REMARKS

Annotated Sheet Showing Changes
Serial No. 10/607,138 Filed: June 27, 2003
HACK et al. Atty Dkt No.: 10020/28501
Art Unit: 2818 Ex.: T.T. Nguyen

Figure 8 of Kimura '123 illustrates an example pixel:

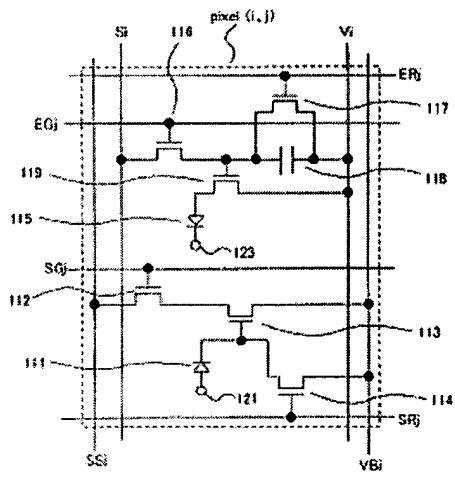
A description of this figure can be found in paragraphs [0118] to [0132]. The lines are described as follows: resetting signal line ER, selecting signal line EG, sensor selecting signal lines SG, sensor resetting signal lines SR, sensor signal output line SS, source signal line S, power supplying line V, and sensor power supply lines VB.

Photodiode 111 (sensor) is connected to a power supply reference line 121. While not described in the context of Figure 8, power supply reference line 121 is described elsewhere in the disclosure as having a potential of 0V. *See* paragraphs [0137] and [0141]. Light emitting element 115 is tied line 123, which is not described.

There is no disclosure of modulating any of the plural power supply lines in Kimura '123. At the Interview, the Examiner suggested that Figure 18 (adjacent) shows modulation of a pulse width of a power signal transmitted through a power line.

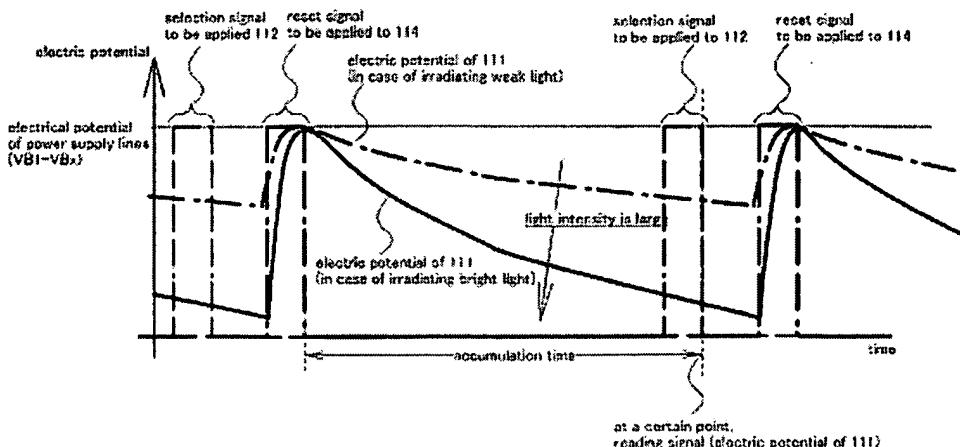
However, in Figure 18 of Kimura '123 (below), power supply line VB is clearly illustrated as having a constant voltage, with only selection signals (112, 114) being modulated. Further, the potential across photodiode 111 (sensor) fluctuates not because of

a modulation of the power lines, but in response to reading a black calibration sheet after the pixel is reset. *See, e.g.*, paragraphs [0162] to [0167].

FIG. 6

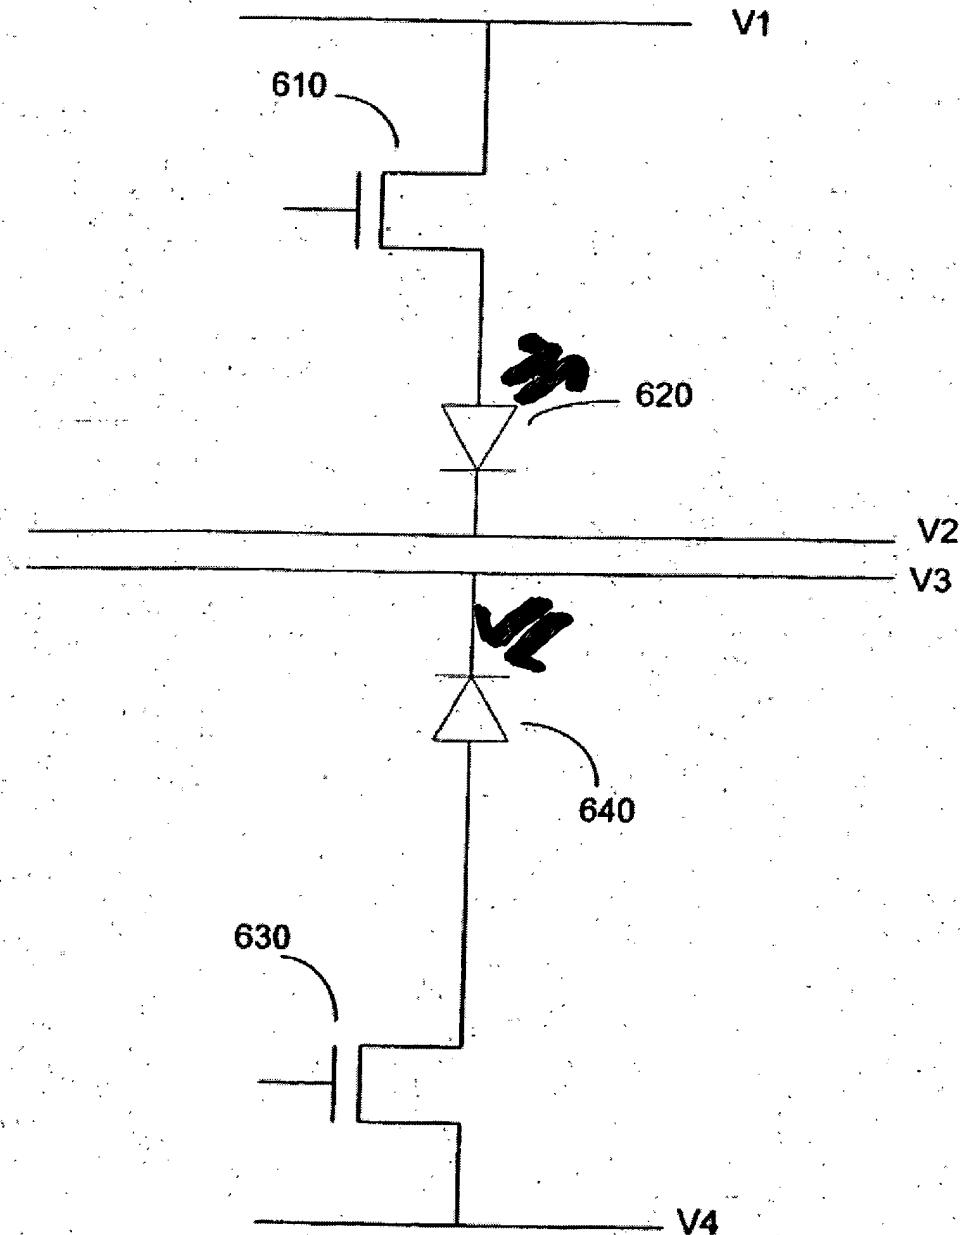
In accordance with the Examiner's instructions, replacement drawings adding "light arrows" to Figure 6 and Figure 17 are submitted herewith. Withdrawal of the objection to the drawings is requested.

The attached sheets of drawings include changes to Figs. 6 and 17. These sheets, which include Figs. 6 and 17, replace the original sheets of Figs. 6 and 17. In Figs. 6 and 17, “light arrows” are added, as requested by the Examiner.

Figure 17

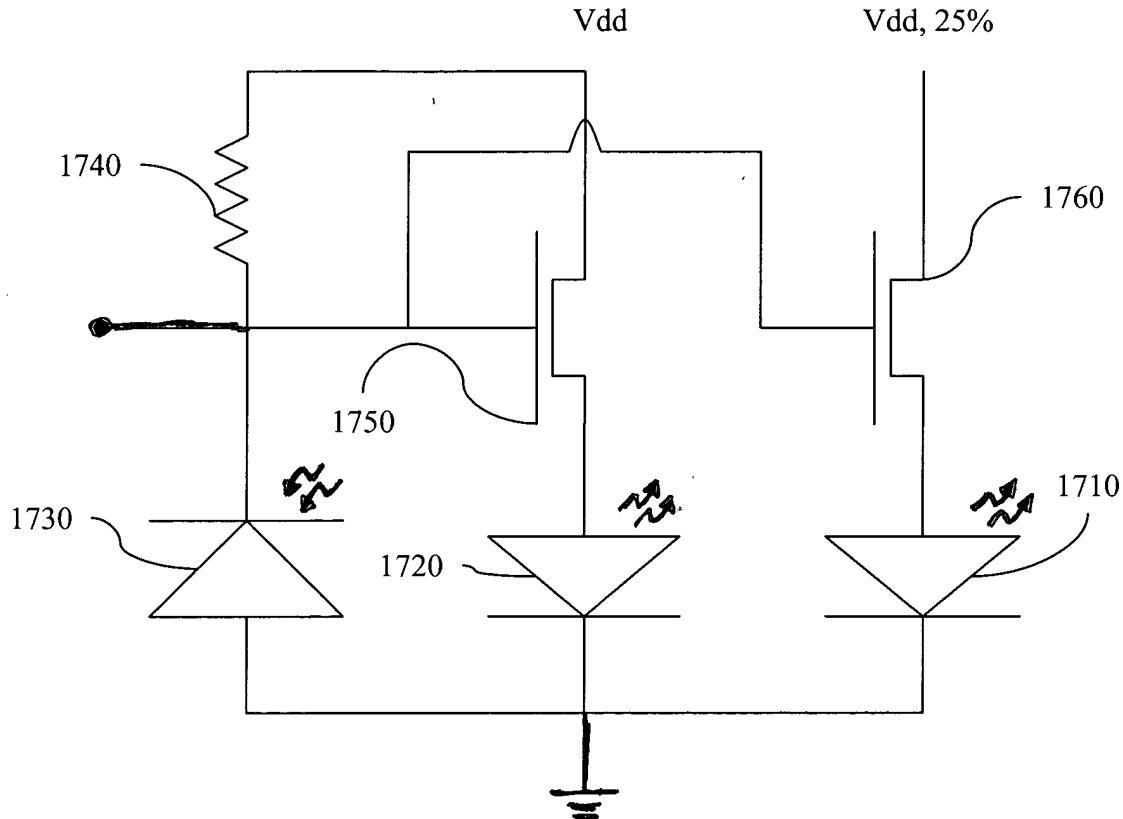
Additionally, to clarify operation of the circuit in Figure 17, Applicants propose adding a connection to a negative power supply (*e.g.*, ground) at the bottom of the figure, and a control signal input line tied to the gate of transistor 1750. This feature is described in paragraph [0077]. The need for the negative power line can be understood from the description of the operation of the circuit. For example, the power line (Vdd) that powers second OLED 1720 may be "always on or unmodulated," such that the light emitted by OLED 1720 "is not interrupted when the subpixel is in the ON state." Implicit is a path for current from Vdd through OLED 1720 to a negative power line. Support for adding a connection to the gate of transistor 1750 can be understood from the passage stating that "the state of the subpixel may be changed by applying a signal to the gate of transistor 1750." These additions to the figure are proposed in an effort to make operation of the circuit in FIG. 17 readily apparent to the casual observer. Approval is requested.

Additionally, as explained on below, Applicants have amended Figure 17 to clarify operation of the circuit in Figure 17.
